RE: Kendall Bay Sediment Remediation Project (SSD 6701) – Department of Industry Submission on Environmental Impact Statement.

Kendall Bay Sediment Remediation Project (6701) EIS Exhibition

Figure 1: Proposed concept design of the Rock Groyne (Seawall Extension)

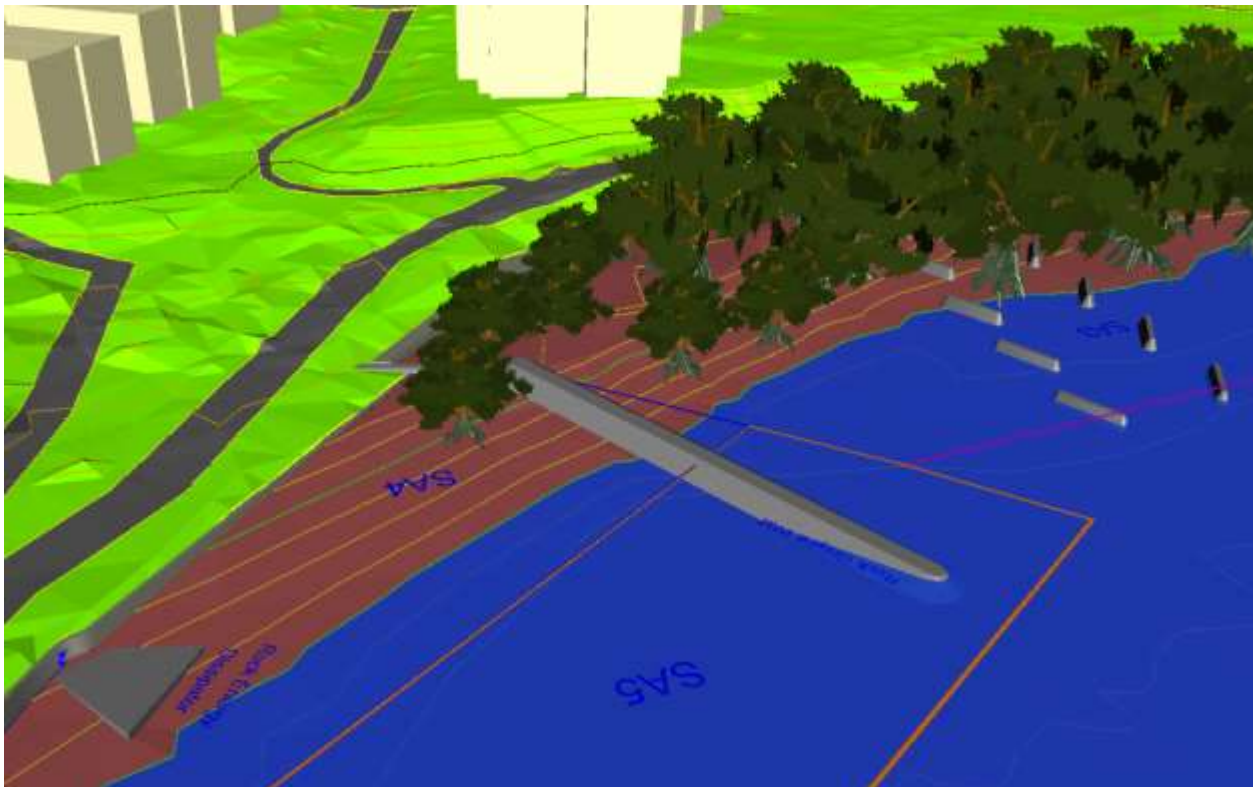
- The department requests further information on the dimensions of the 30m wall to be constructed in area SA4 and what it will likely be constructed with. A rip rap design to promote aquatic habitat diversity over time is recommended.

The approach to the construction of the rock groyne wall is described below. We believe this design meets Fisheries recommendation for a rip rap design which promotes aquatic habitat diversity on this wall over time.

The small groyne wall is an extension to the existing seawall and will be used to contain the replenished material in SA4 and SA5. The concept design is presented below within the rendered NAVISWORKS model.
